Title - Sujet Const. Fire Pump Bldg-Green Gables	
Solicitation No. - N° de l'invitation ED001-202970/A	Amendment No. - N° modif. 006
Client Reference No. - N° de référence du client ED001-202970	Date 2020-04-20
GETS Reference No. - N° de référence de SEAG PW-\$PWC-033-4500	
File No. - N° de dossier PWC-9-42062 (033)	CCC No./N° CCC - FMS No./N° VME
Solicitation Closes - L'invitation prend fin at - à 02:00 PM on - le 2020-04-23	
Time Zone Fuseau horaire Atlantic Daylight Saving Time ADT	
F.O.B. - F.A.B. Plant-Usine: <input type="checkbox"/> Destination: <input checked="" type="checkbox"/> Other-Autre: <input type="checkbox"/>	
Address Enquiries to: - Adresser toutes questions à: Young (PWC), Leesa	Buyer Id - Id de l'acheteur pwc033
Telephone No. - N° de téléphone (506) 871-1716 ()	FAX No. - N° de FAX (506) 851-6759
Destination - of Goods, Services, and Construction: Destination - des biens, services et construction:

This solicitation amendment No. 006

Title: Fire Protection and Emergency Power Building and System
Parks Canada Green Gables (Phase 4)
Cavendish, Queen's County, PEI

House Existing Fire Alarm Panel

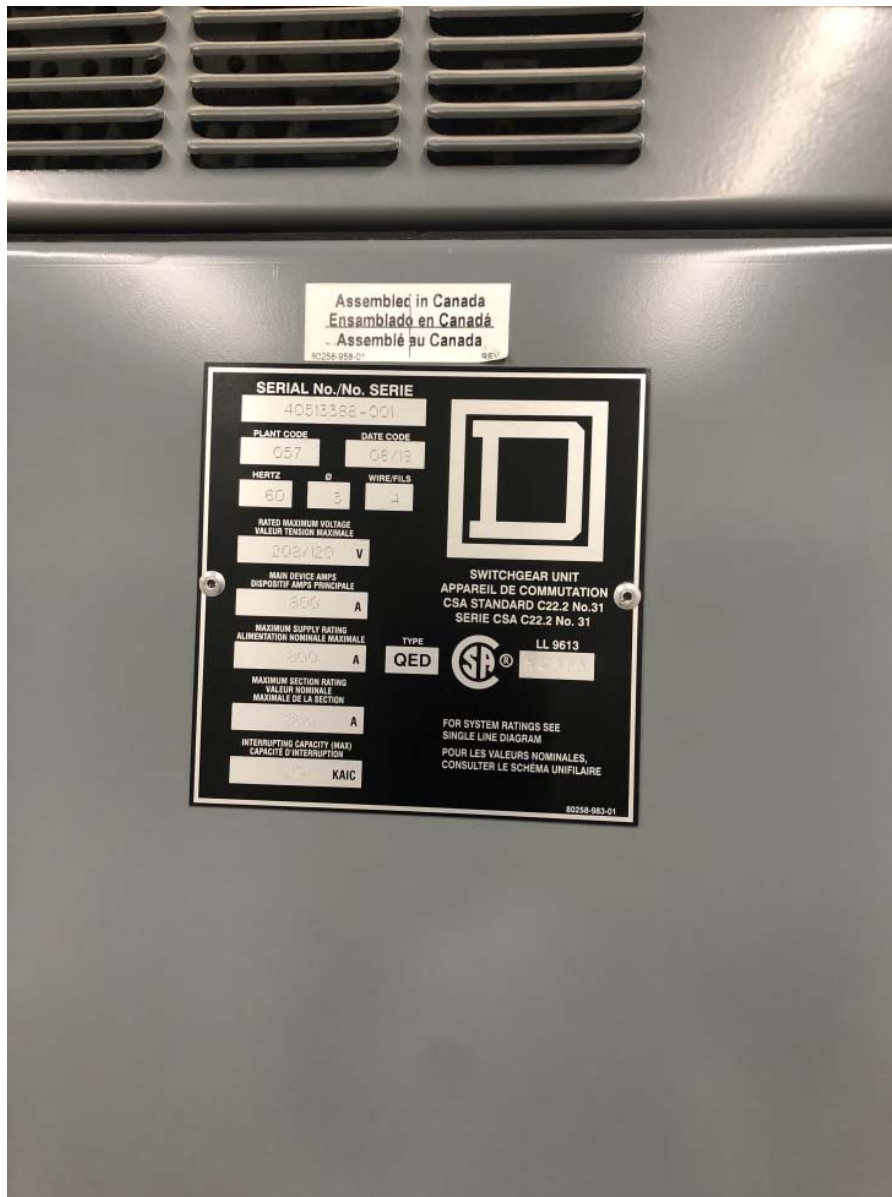
Q26: Need confirmation of the manufacturer and model of the existing fire alarm panel in order to supply the correct components for the new buildings.

R26: See attached photos Visitor Centre Existing Fire Alarm Panel and House Existing Fire Alarm Panel.
